Date: Monday, July 12, 2021
To: Richard F. Gosselin, Jr, Chairman; Paul A. Piktelis, Vice Chairman; Terry Burke Dotson, Member; Mathew Ashmankas, Member; Bruce M. Devault, Member; and Millbury Planning Board
From: Steven S. Stearns
Reference: Public Hearing Comments (from a son of the owners and resident of **Map 62 Parcel 98**)
McLaughlin Family Living Trust; John Antaya; and Kathleen (McLaughlin) Mardirosian (the “owners”)
Whitney Street Home Builders, LLC (the “developer”)
17 Rice Road, Millbury, MA (a/k/a Rice Pond Village Project)

SITE PLAN OF PROPOSED IMPROVEMENTS TO RICE ROAD AT RAILROAD CROSSING IN MILLBURY, MA

PLAN OF PROPOSED INTERSECTION IMPROVEMENTS AT RICE ROAD AND SOUTH MAIN STREET
 IN
 MILLBURY, MASSACHUSETTS

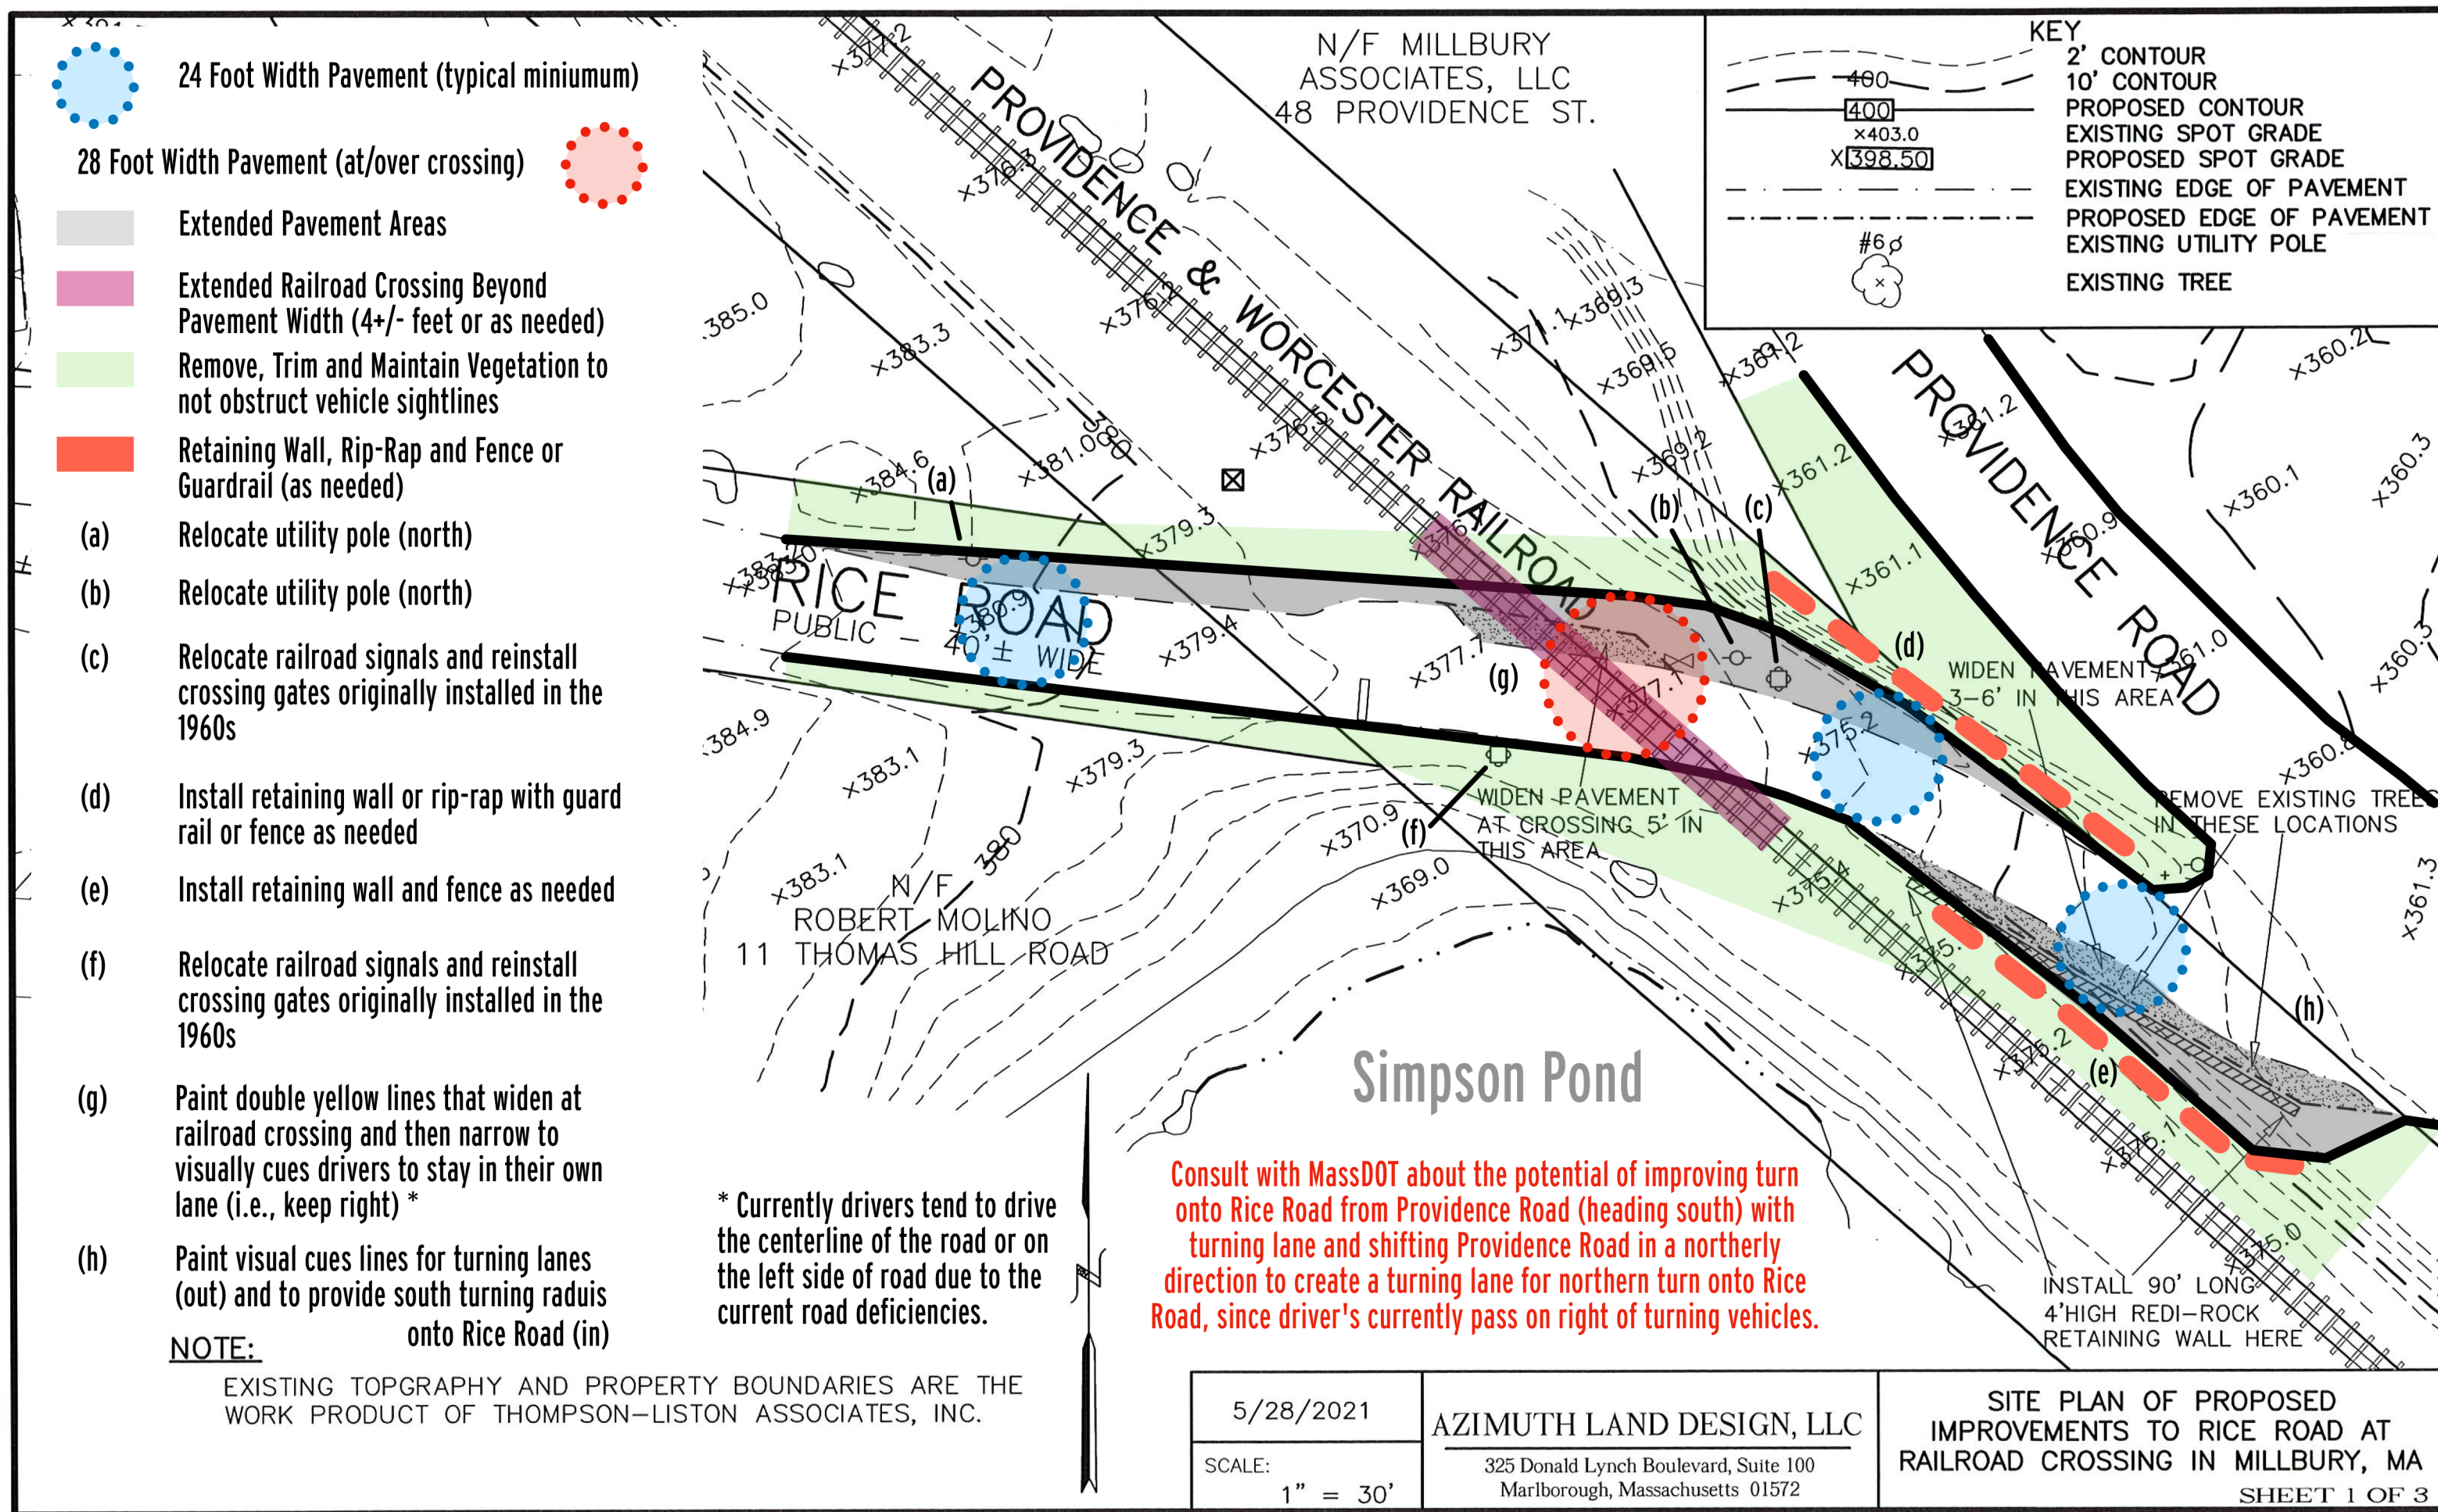
1. The width of the railroad crossing should be increased to a minimum of 28-feet to provide for an adequate and safe crossing and added painted cross-hatched lines that increase as vehicles approach the railroad crossing and then decrease after crossing the railroad tracks, indicating to drivers to stay in their own lanes. Today, people drive on the wrong side of the road or in the center of the road.

2. Rice Road width throughout should have a minimum width of 24-feet of finished pavement without exception, add an appropriate center line painted lines, as deemed appropriate by the Millbury Department of Public Works or other traffic standards.

3. This railroad crossing originally had crossing gates in the 1960s, 1970s, and maybe into the 1980s. These gates should be restored to ensure the safety of traffic, the same as the Curve Street and South Main Street railroad crossings.

4. Create turning lanes at Providence Road (north and south) and add a stop sign(s) at the end of Rice Road.
5. Restore railroad crossing signs and pavement marking to ensure awareness of drivers that the crossing exists, also add a sign that indicates the sharp angle change .

24 Foot Width Pavement (typical minimum)

28 Foot Width Pavement (at/over crossing)

Extended Pavement Areas

Extended Railroad Crossing Beyond Pavement Width (4+/- feet or as needed)

Remove, Trim and Maintain Vegetation to not obstruct vehicle sightlines

Retaining Wall, Rip-Rap and Fence or Guardrail (as needed)

(a) Relocate utility pole (north)

(b) Relocate utility pole (north)

(c) Relocate railroad signals and reinstall crossing gates originally installed in the 1960s

(d) Install retaining wall or rip-rap with guard rail or fence as needed

(e) Install retaining wall and fence as needed

(f) Relocate railroad signals and reinstall crossing gates originally installed in the 1960s

(g) Paint double yellow lines that widen at railroad crossing and then narrow to visually cue drivers to stay in their own lane (i.e., keep right) *

(h) Paint visual cues lines for turning lanes (out) and to provide south turning radius onto Rice Road (in)

* Currently drivers tend to drive the centerline of the road or on the left side of road due to the current road deficiencies.

Consult with MassDOT about the potential of improving turn onto Rice Road from Providence Road (heading south) with turning lane and shifting Providence Road in a northerly direction to create a turning lane for northern turn onto Rice Road, since driver's currently pass on right of turning vehicles.

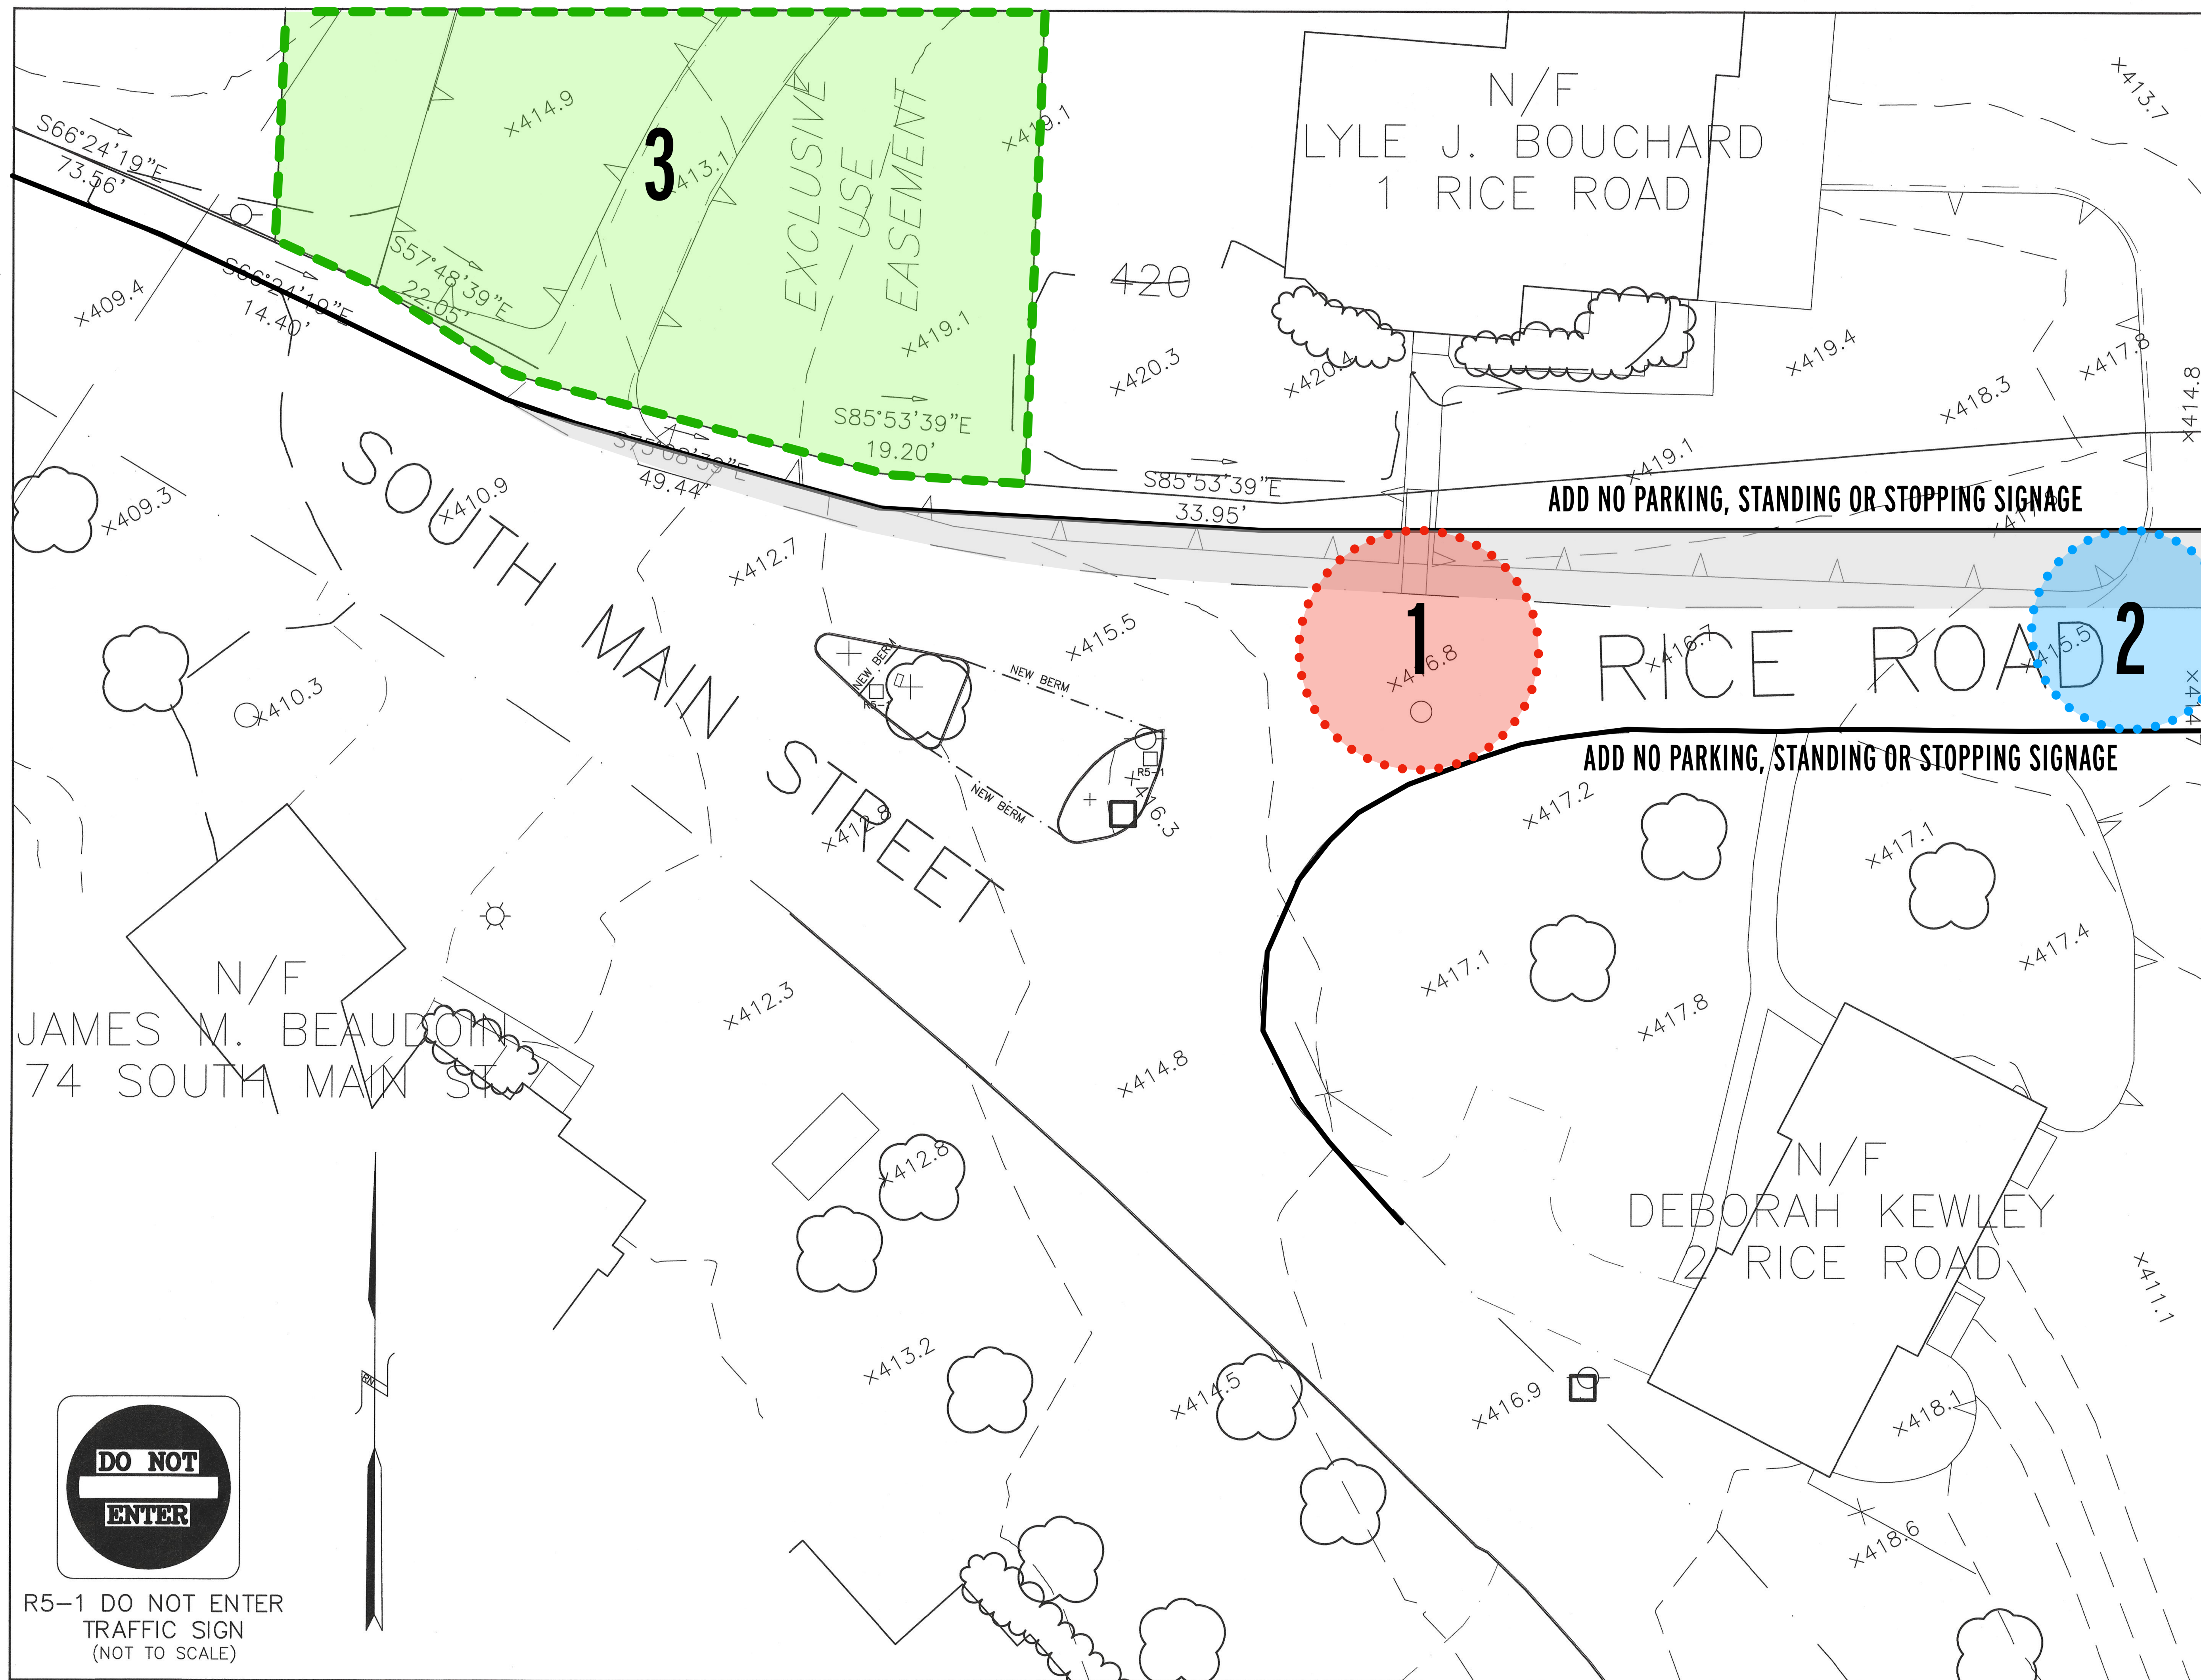
In reviewing the developer's engineer's proposed enhancements to the Rice Road / Providence Road intersection (and railroad crossing) and Rice Road / South Main Street, their proposed plans unfortunately miss the mark and do not fully address the concerns of the neighborhood or Planning Board members. As a long-time resident, from listening to other neighbors, and the Planning Board members comments, I have taken some time to mark up their proposed plan with alternatives for each intersection for discussion and refinement purposes. Please note that the alternative plans submitted are not to scale.
